HARTFORD PLANNING COMMISSION

**DRAFT
FINDINGS OF FACT
CONCLUSIONS OF LAW
AND
DECISION**

**Application #24-01 by Guernsey Ruth Hall Revocable Trust and
Summit Distributing
for Site Development Plan Approval
for approval of a car wash
lot 44-0041-000, Sykes Mountain Avenue
White River Junction, in an IC zoning district**

SUBJECT: Response to Comment
Proposed Car Wash
Lot 44-0041-00

SITE PLAN

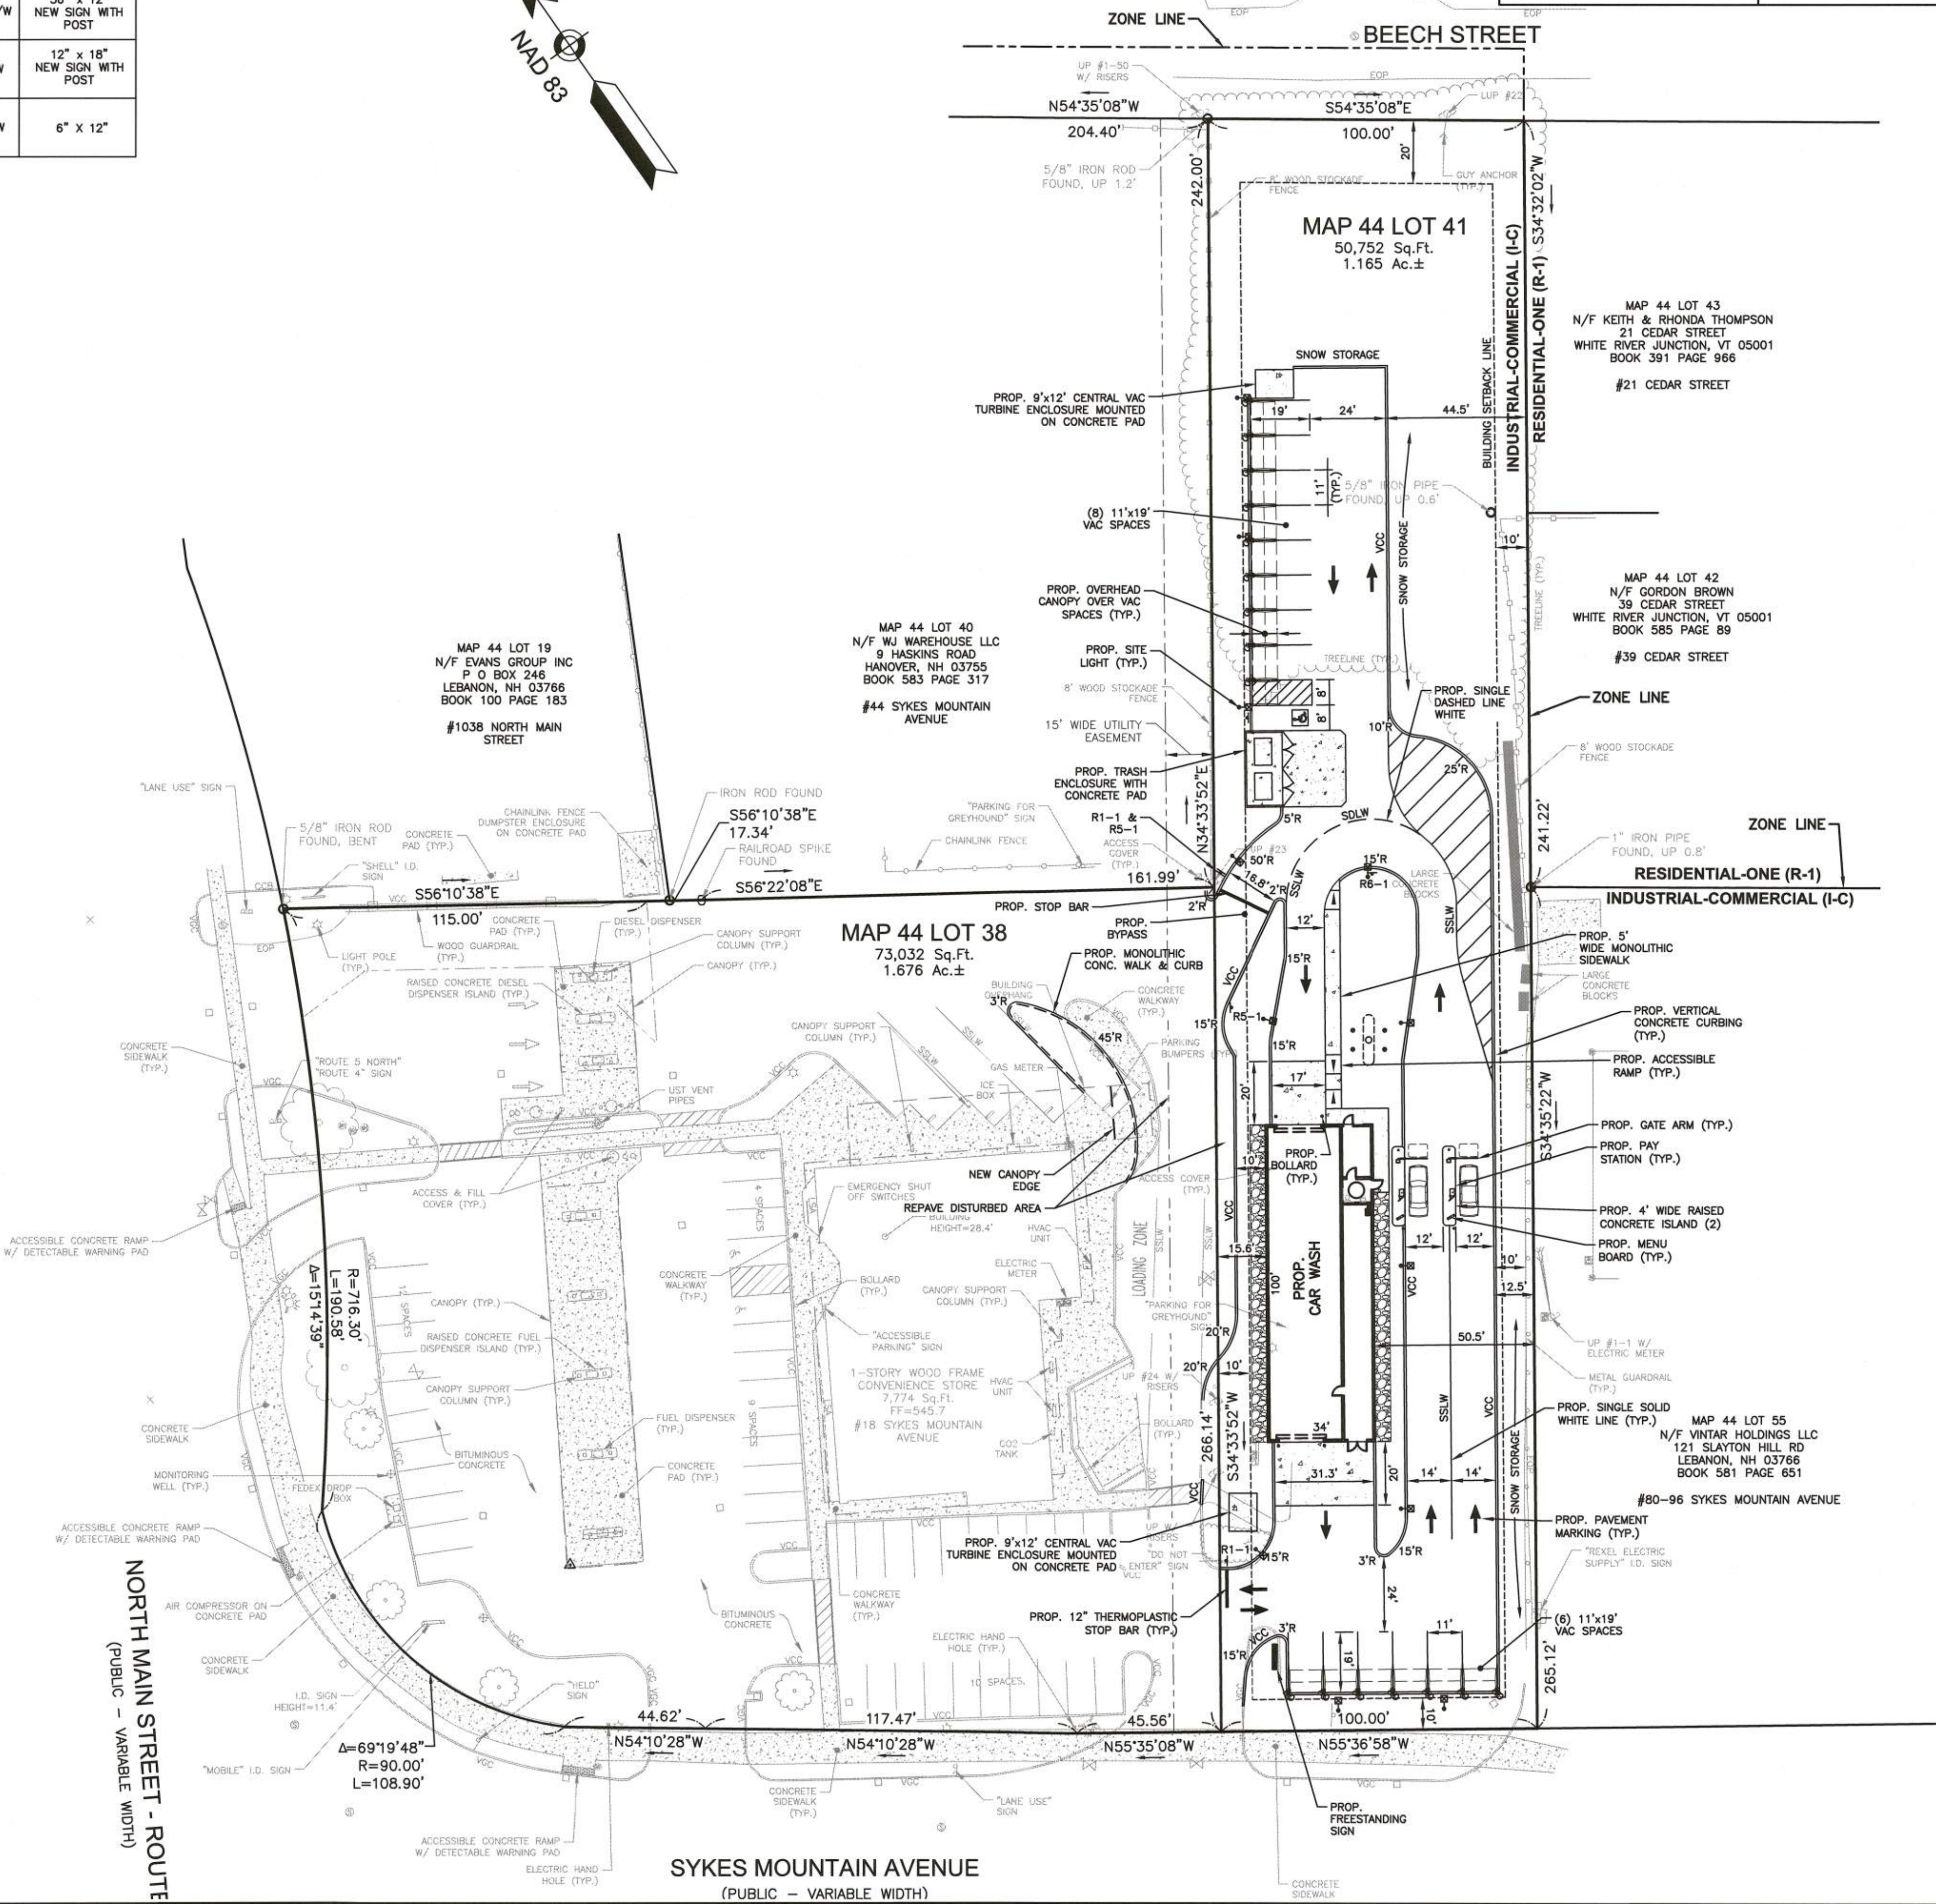
- **The plans are amended to include the location, height, and material for the proposed fence.**
- **The applicant submits copies of applicable access easement(s) to support the proposed traffic pattern.**
- **The applicant submits written verification from the Fire Marshal confirming they have reviewed and approved the turning movement plan for the ladder truck.**
- **A “Do Not Enter” sign is added to the plans to restrict access to the back of the lot from the rear of lot 44-0038-000.**
- **The applicant adequately addresses the questions outlined in the February 21, 2024 email from Jo-Ann Ells. (See exhibit #7)**
- **The note on plan sheet #5 referencing an “overhead canopy” for the rear vacuums is removed.**

Response: This information is provided on the Site Plan, sheet 5.
- Consider adding plantings on the west side of the parking spaces at the rear of the lot

**GRADING &
DRAINAGE
PLAN**

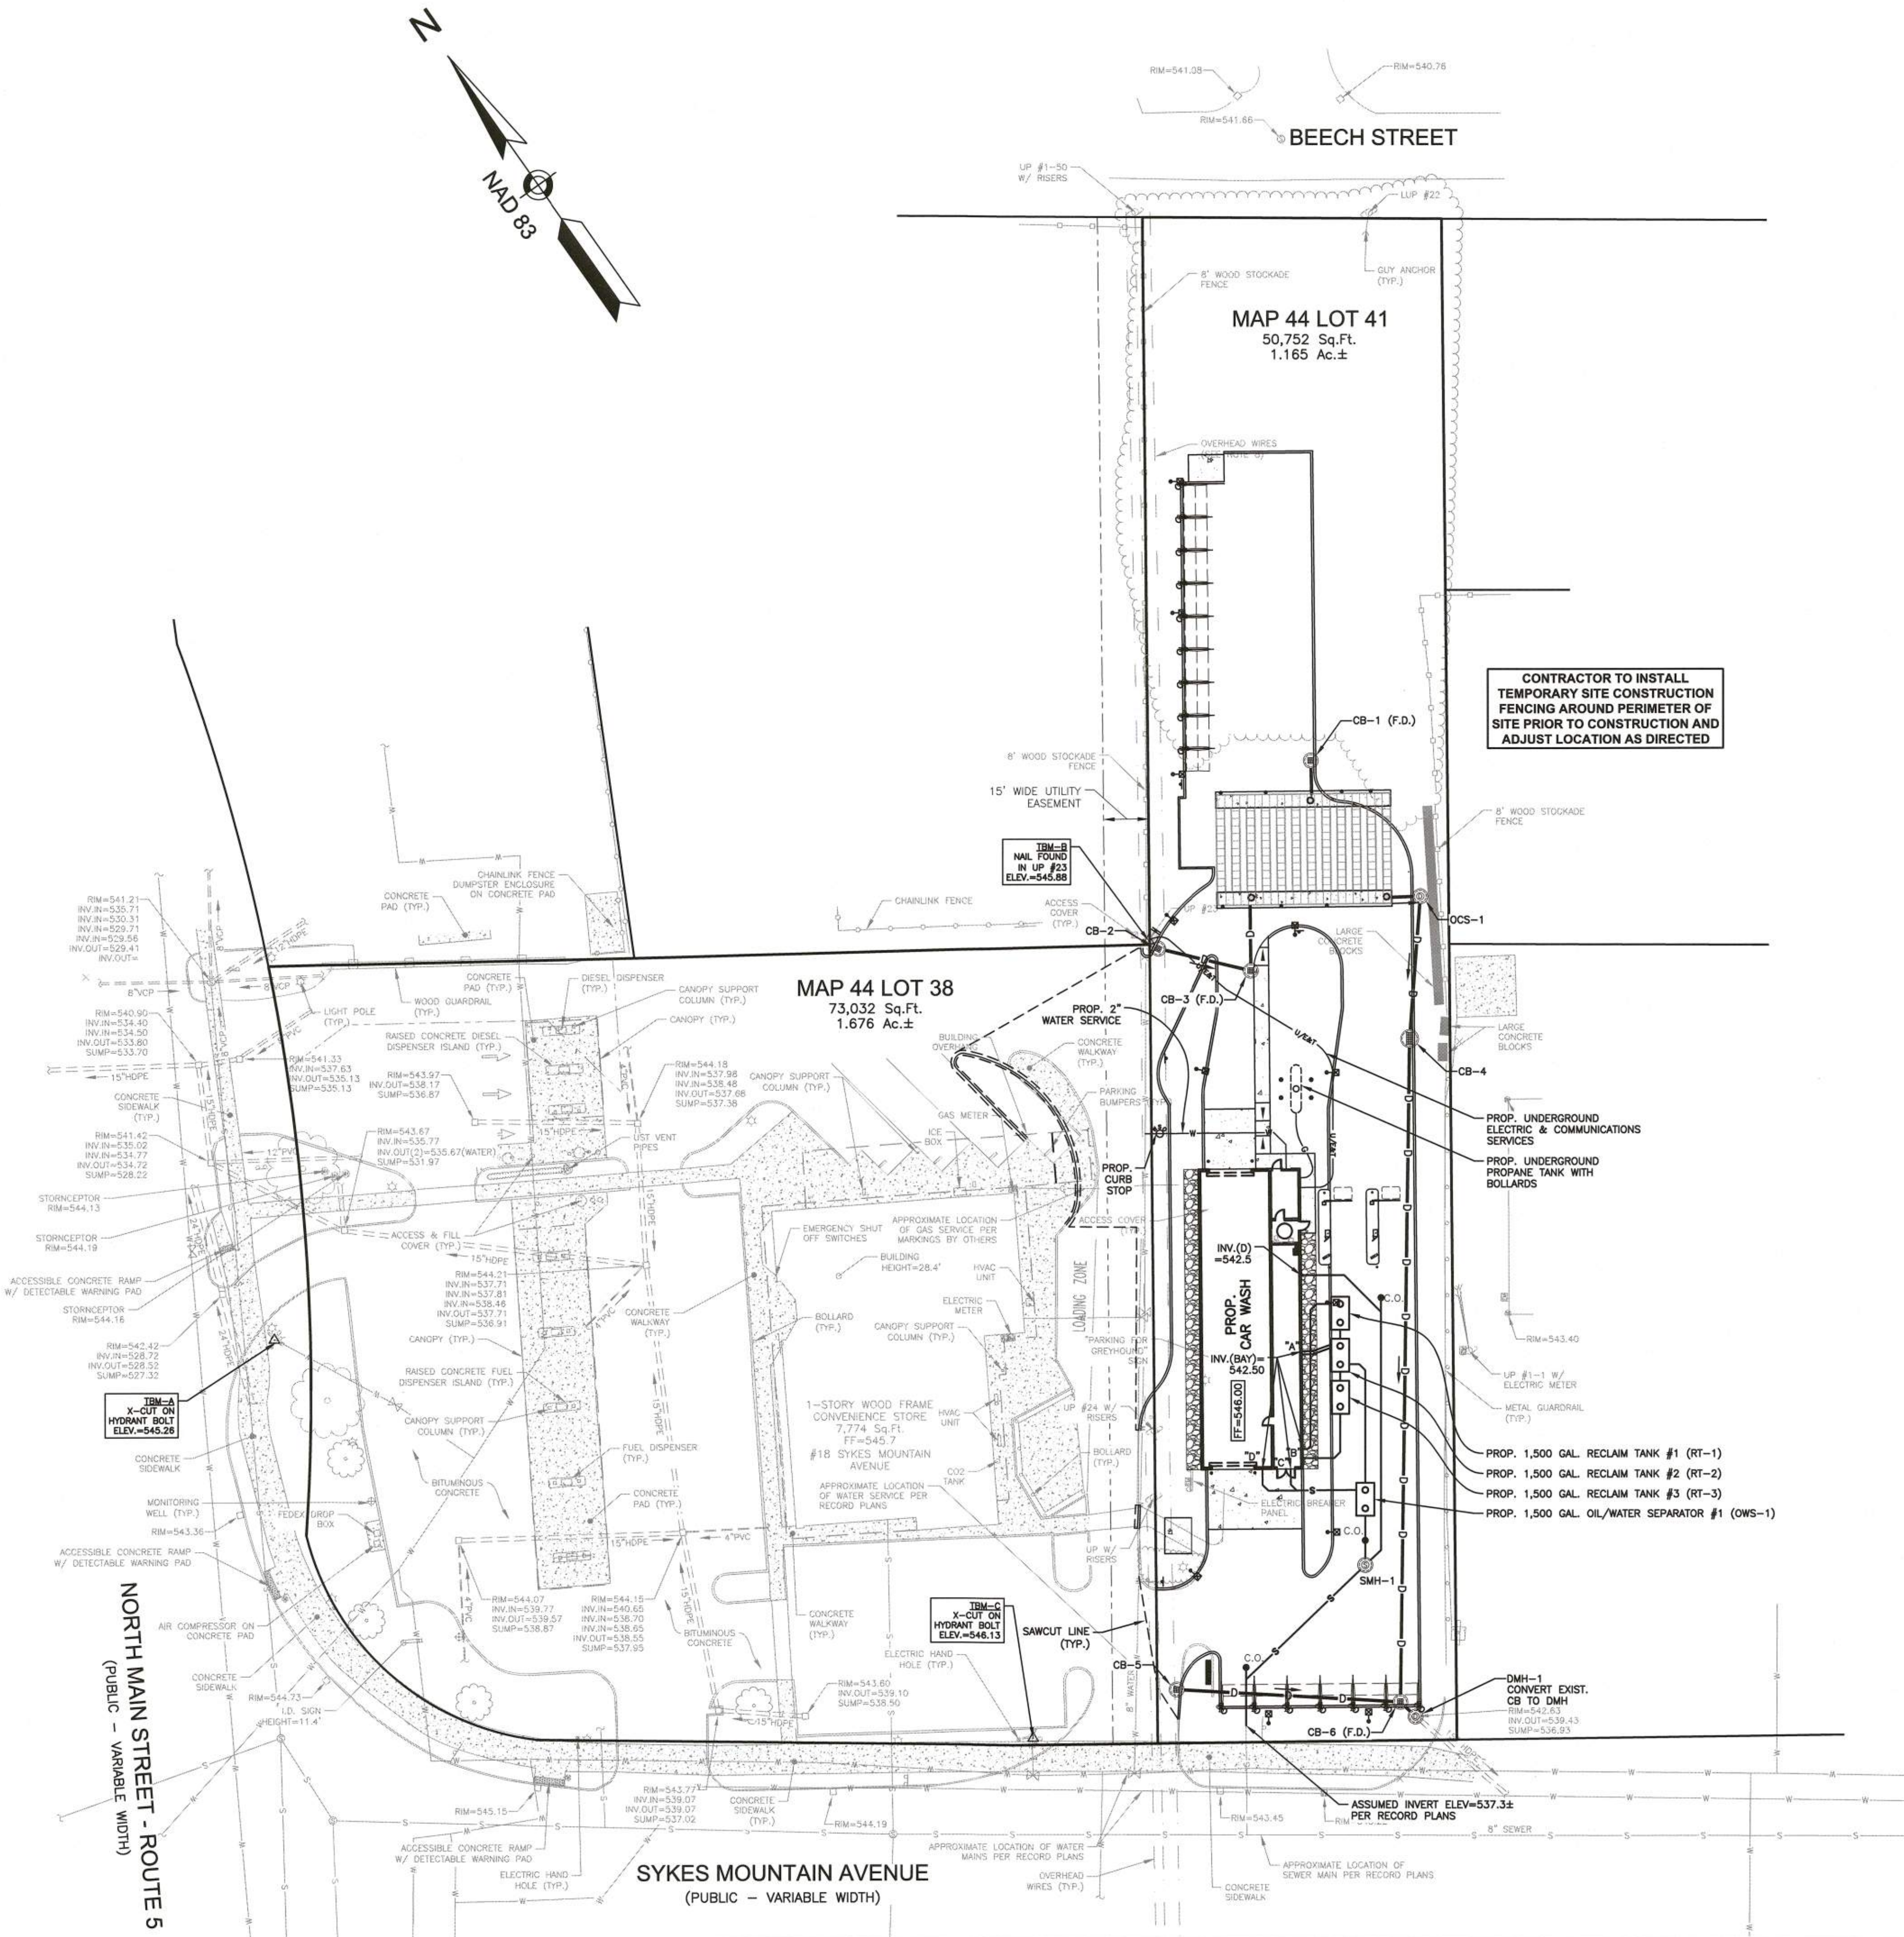
Response: The HSG D was taken directly from the NRCS soil map (Appendix B). We have revised the HydroCAD calculations to model the soils as HSG C. The calculations continue to show no increase in discharge rates leaving the site. We did not perform any test pits or infiltration tests in the area of the infiltration trench due to the presence of existing pavement or underground tanks. The test pit locations were mistakenly omitted from the plans and have been added to the revised plans (see sheet 6).
